# Specification for the Reinstatement of Openings in Highways- Electric Vehicle addendum

December 2024

It is an addendum to the <u>Specification</u> for the reinstatement of openings in highways (SROH), 4th edition.

### Figure S1.2 Location of cable channels in footways and footpaths

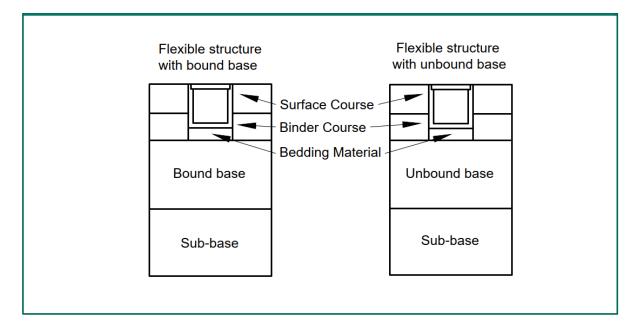
S1.8.2a Cable channels are allowed within the footway and footpath structure (see Figure S1.2) when excavation and reinstatement are carried out following this addendum.

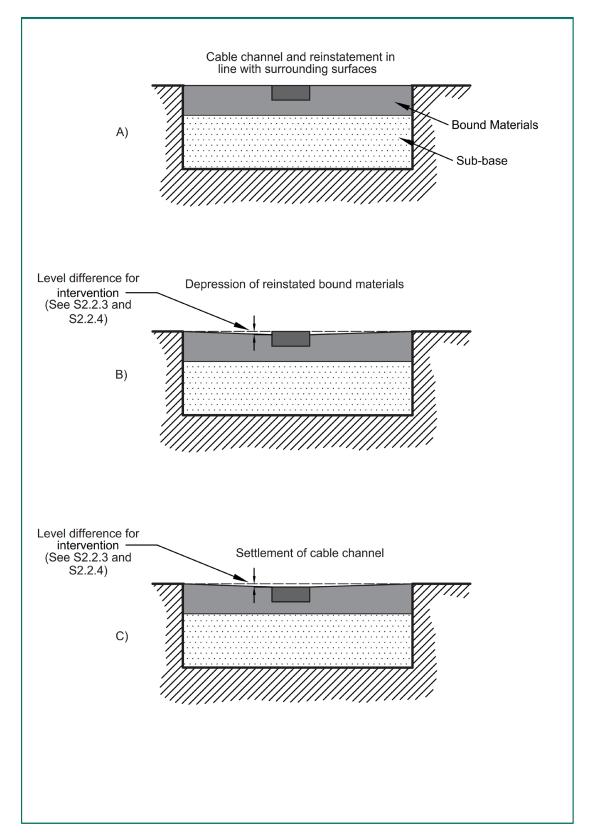
S2.3.2a Figure S2.6 illustrates the relationship between immediately adjacent surfaces and the surround reinstatement when setting the level of cable channels.

### Figure S11.2 Reinstatement around a cable channel

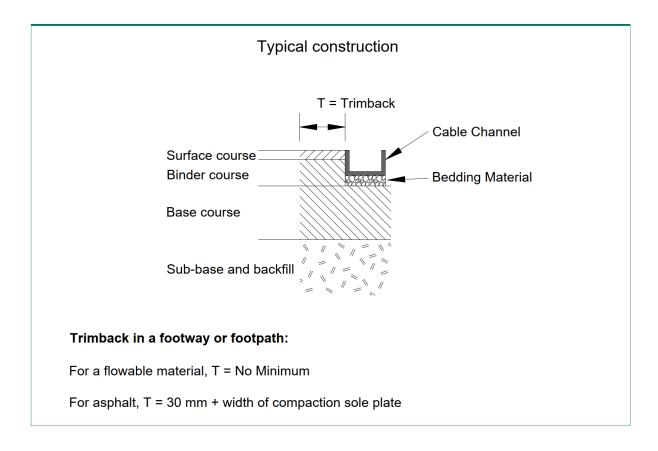
S11.5.17a Figure S11.2 shows typical reinstatement around a cable channel.
